The Locomotive Emissions Sourcebook

Revision 0

Nov 7, 2022

Comments on Proposed CARB In-Use Locomotive Regulations Rule

Figure 1 - NO_x Table from ARB Emissions Report

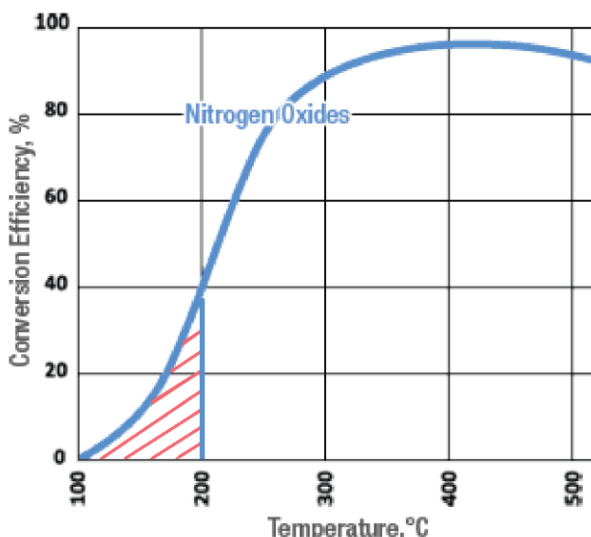
The Cummins line is what would be expected from Figure 1, the NOx data points from dynamic brake through Notch 2 are at very low loads where the exhaust temperatures would remain below 200°C and the DEF injection system would

This agrees with Figure 1 where after turning on the DEF when the exhaust temperature is 200°C, the conversion efficiency is only 40% compared to 95% at

Figure 4 - NOx Emissions vs Power Setting

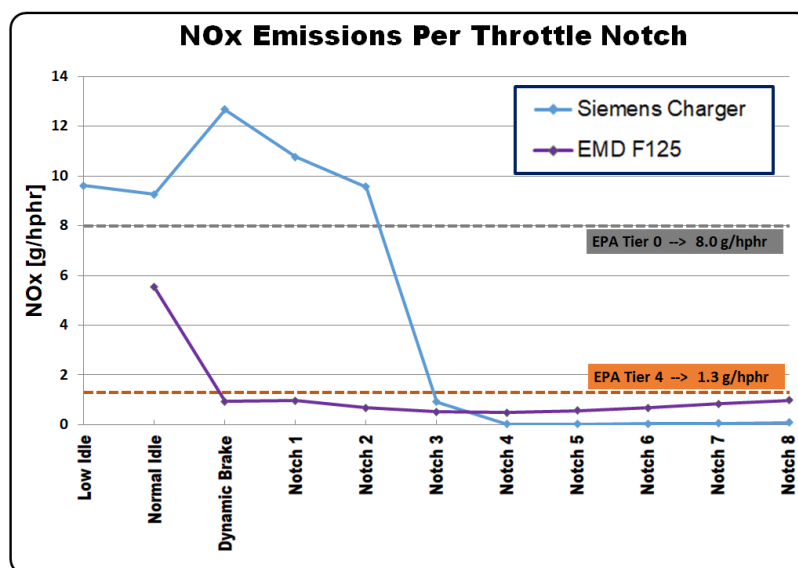
Figure 4 is a chart of the NOx emissions of the two currently available tier 4 certified passenger locomotives in service in the US. These charts are generated from [public EPA data files](#). The vertical axis is the NOx emissions in grams per horsepower hour (g/hphr) and the horizontal axis is the different power settings of the locomotive, including low idle, idle, and dynamic brake followed by eight notches of power. The dashed orange line is set to the EPA Tier 4 NOx standard of 1.3 g/hphr and the dashed grey line illustrates the Tier 0+ NOx

standard of 8.0 g/hphr. The blue line represents the Cummins QSK95 engine used in the Siemens Charger locomotive and the purple line is for the Caterpillar C175-20 engine used in the EMD Rail F125 locomotive. These data points are publicly available in a spreadsheet on the EPA website.

From the different NOx trend lines in Figure 4 and discussions with mechanical personnel familiar with the Progress Rail F125 locomotives at Metrolink, it appears that Caterpillar utilized the engine speed change loophole in the EPA locomotive emissions regulation in order to achieve NOx emissions levels below 1.3 grams/(hp-hr)

If the Caterpillar engine in the Progress Rail locomotive was emissions tested in its normal operating condition with the hotel power system on, its engine RPM would likely be higher and its emissions data in figure 4 for idle through throttle notch 2 would look similar

In figure 4 it is clear that the Caterpillar NOx emissions were 2 to 4 times higher than the Cummins engine from notches 3 thru 8. When this data is input into Figure 8 with 0 HP of hotel power load, it is estimated that the weighted NOx value for inappropriate line haul duty cycle is already over the 1.3 gram NOx standard, at 1.53 grams. When the approximated Commuter duty cycle is used the weighed NOx value jumps to 1.93 gram which is already 48% above the EPA standard without any load on the hotel power system.
